MECHANICAL ADDENDUM NO. MADD-001

Project: Vaughan Willard P.S. – HVAC Upgrades

Date: December 31, 2025

2 SOUTH CLASSROOMS - NE
M-202 SCALE: 1/8"=1'-0"

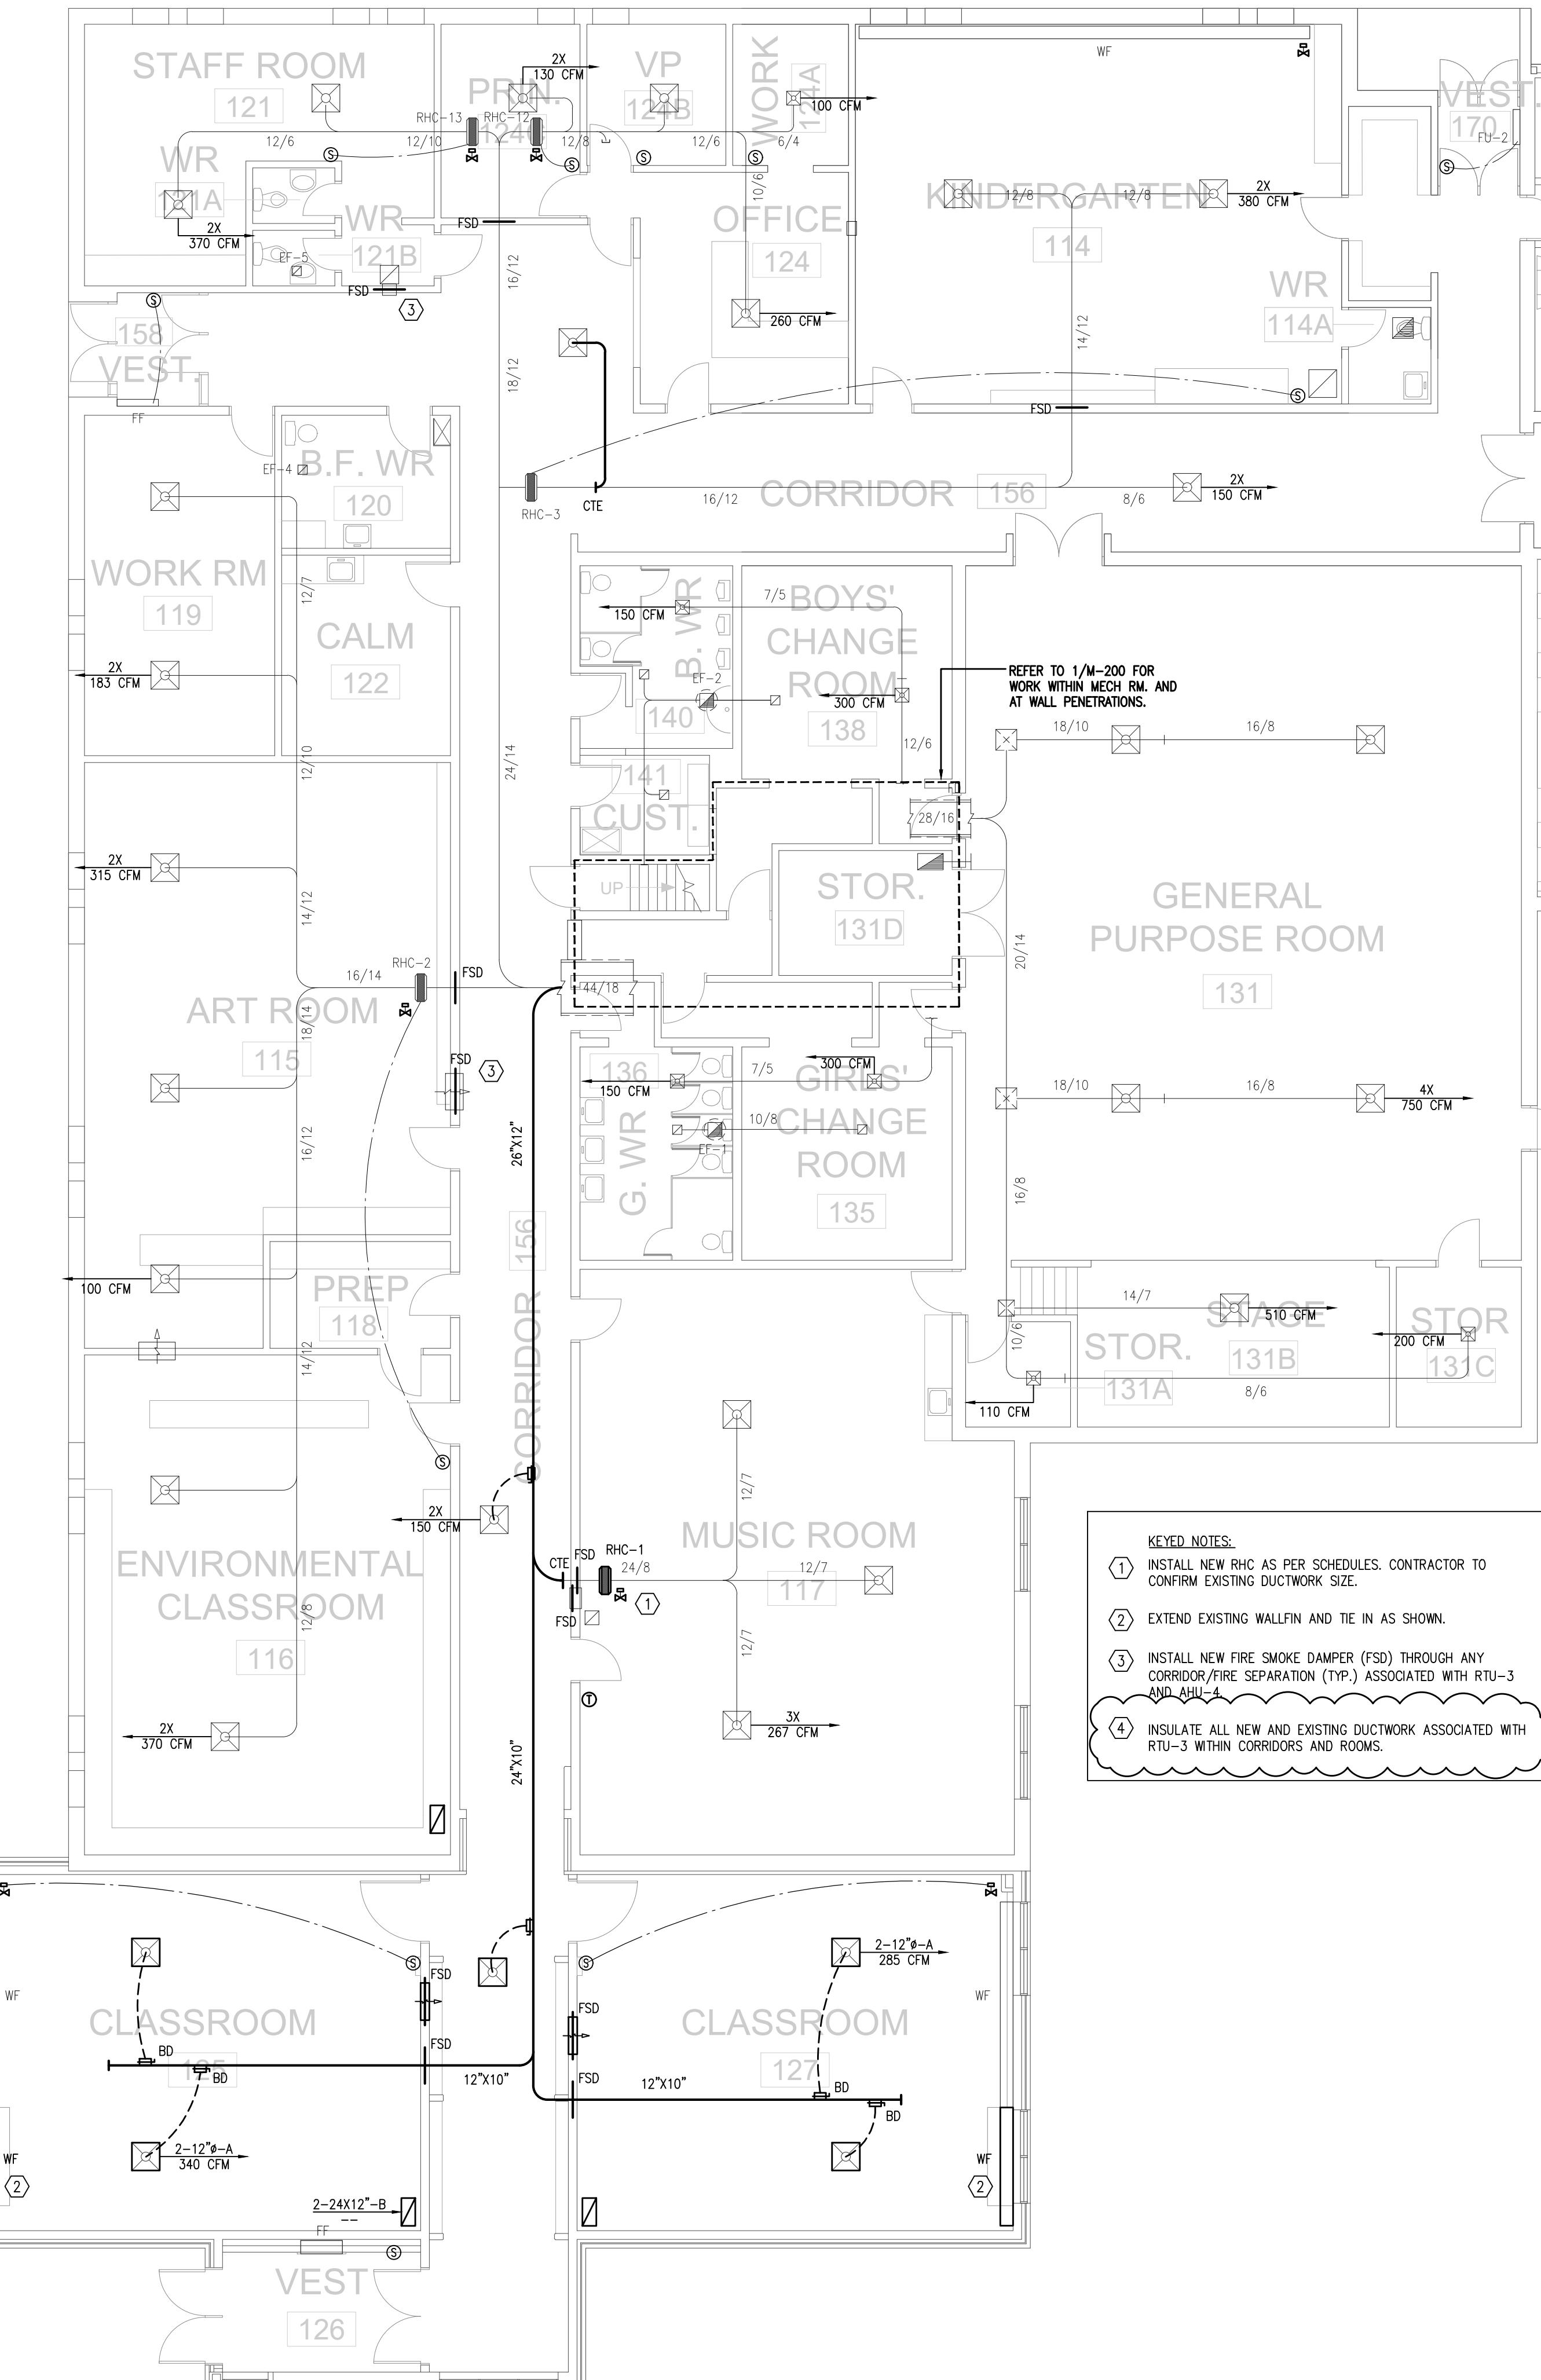
6. Refer to M-201 (Rev. 2) for highlighted changes.
 - a. Revised keyed notes – added keyed note 3.
7. Refer to M-202 (Rev. 2) for highlighted changes.
 - a. 2/M-202: revised keyed notes – added keyed note 4.

1
M-400
ROOF PLAN - HVAC
SCALE: 3/32"=1'-0"

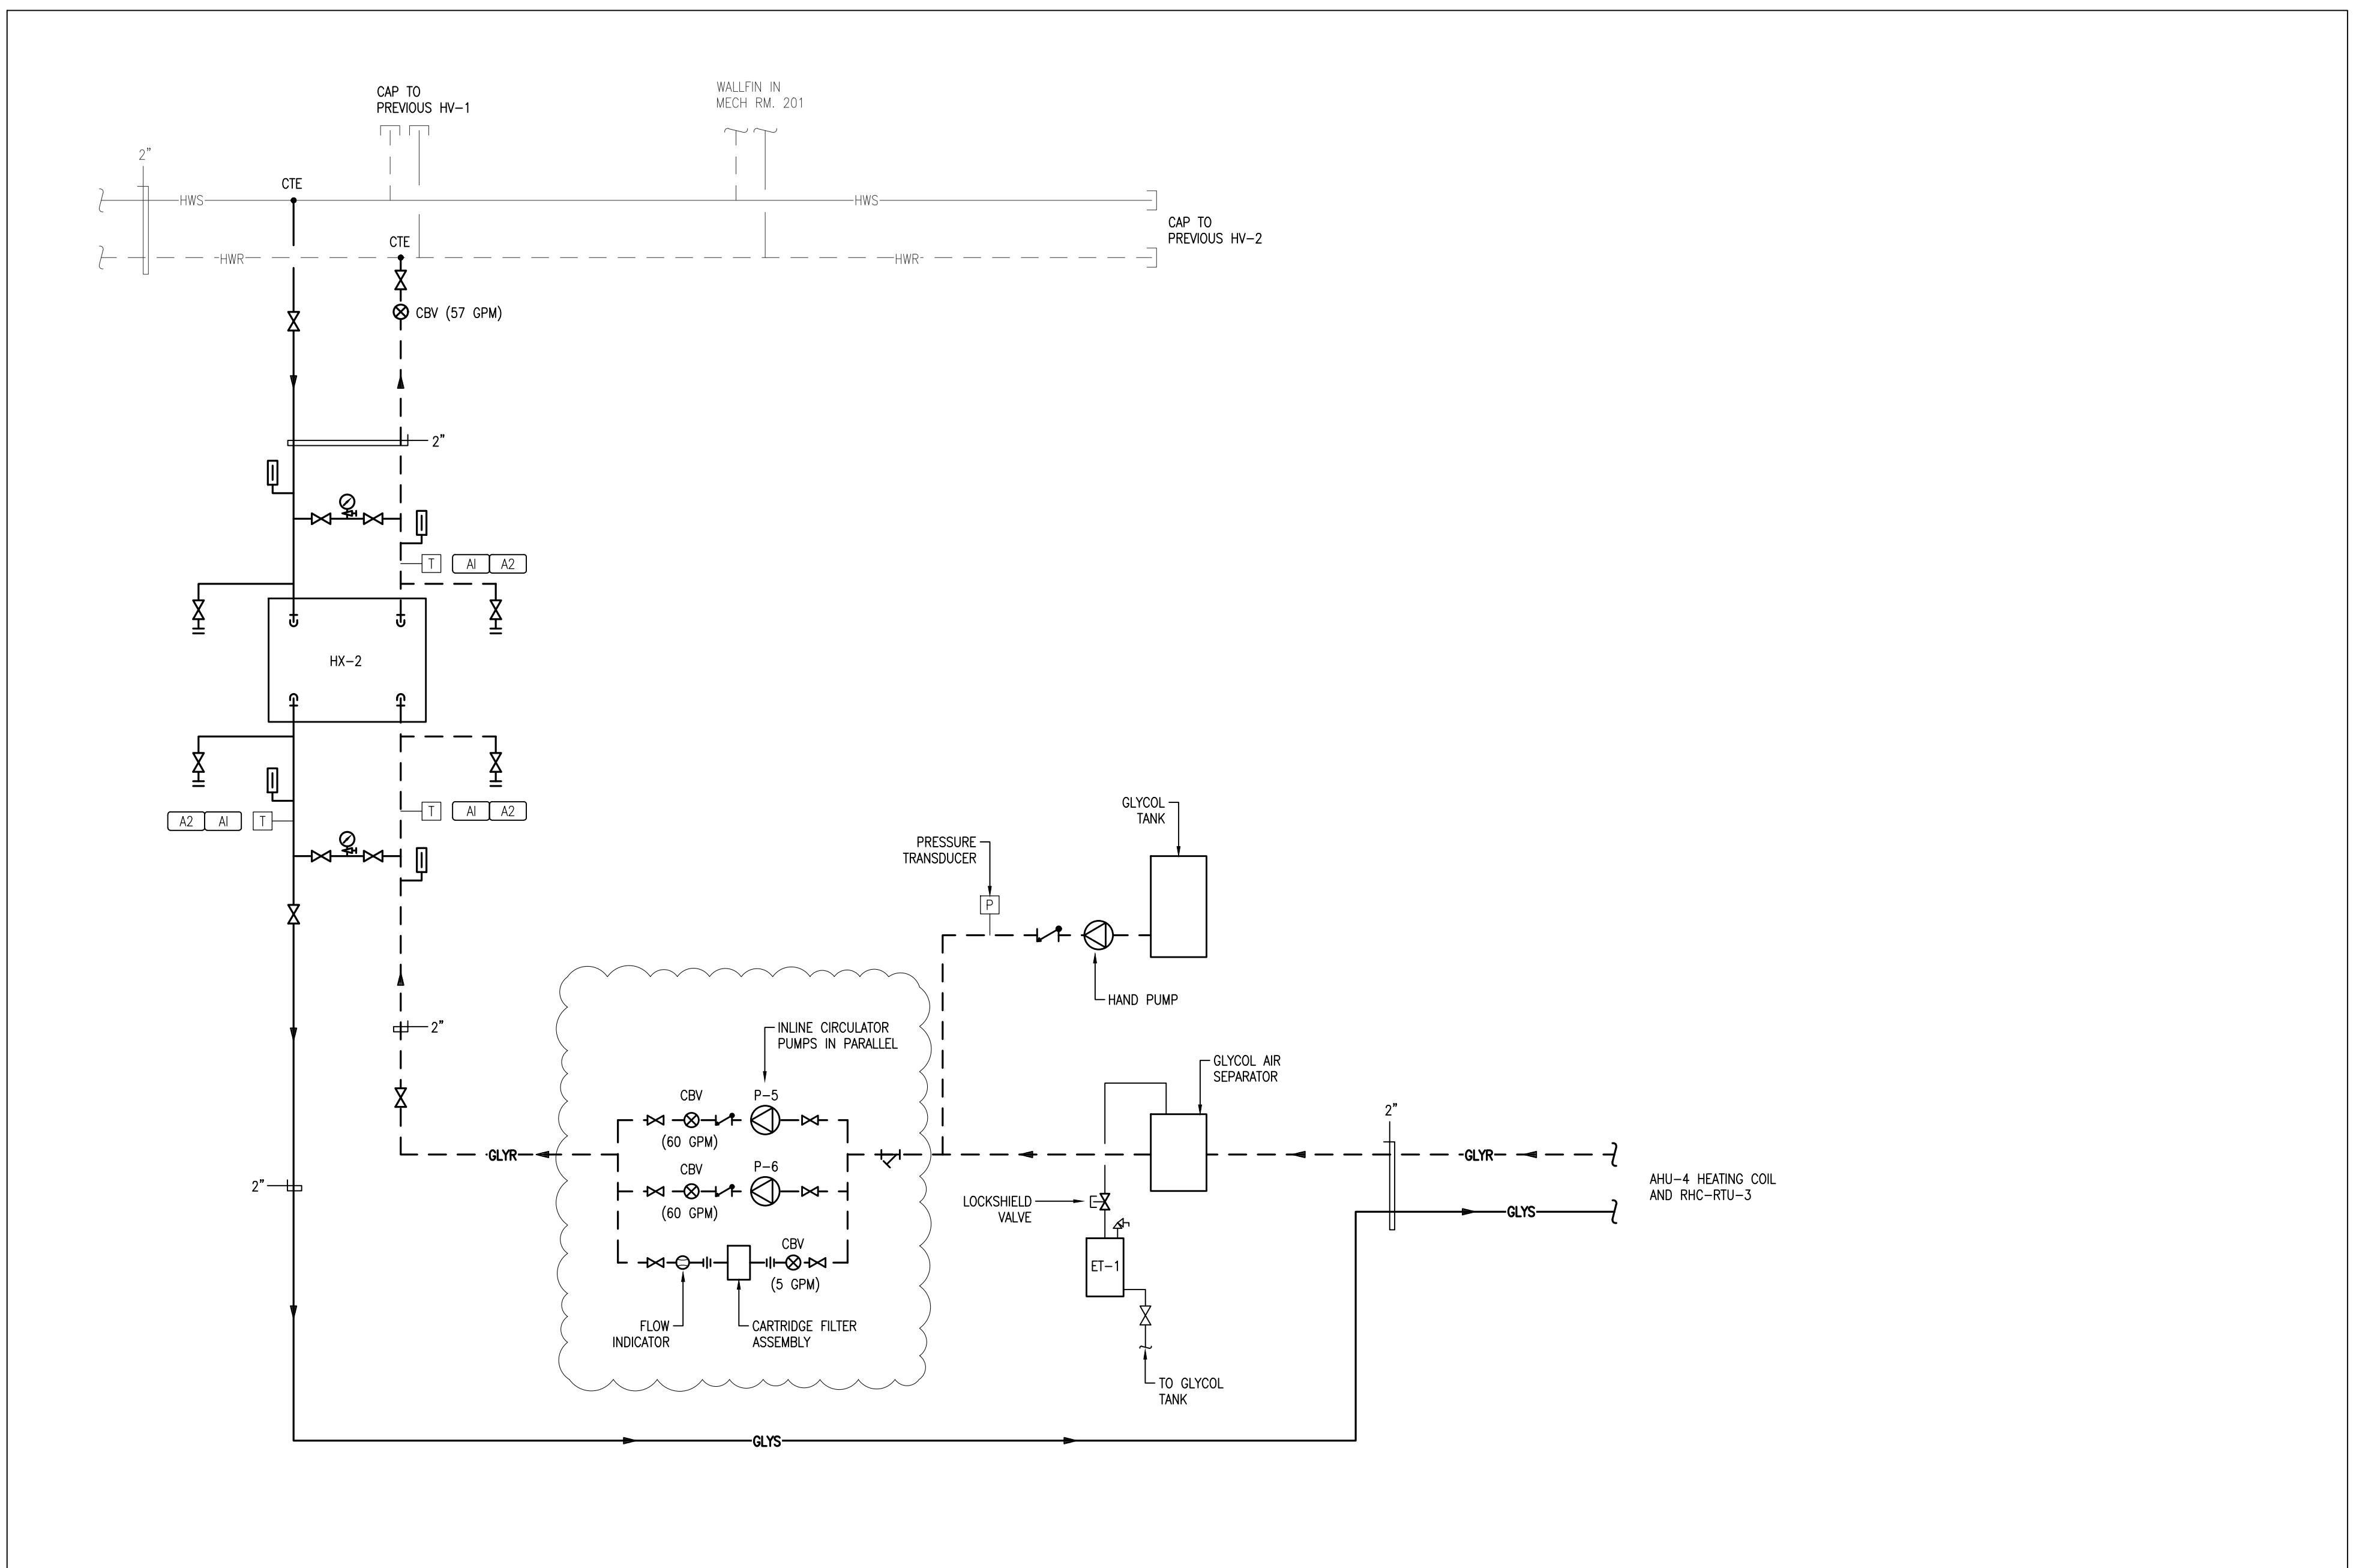
9. Refer to M-400 (Rev. 2) for highlighted changes.
 - a. RTU-3 ductwork location revised, acoustically lined for first 10 ft. from unit.
 - b. CDU-1 location moved South (minimum of 10ft. from roof edge).

- c. Revised keyed notes.
10. Refer to M-500 (Rev. 2) for highlighted changes.
 - a. Revised pumps in schematic – to have single strainer that serves both inline circulator pumps in parallel. Check valve after each individual pump.
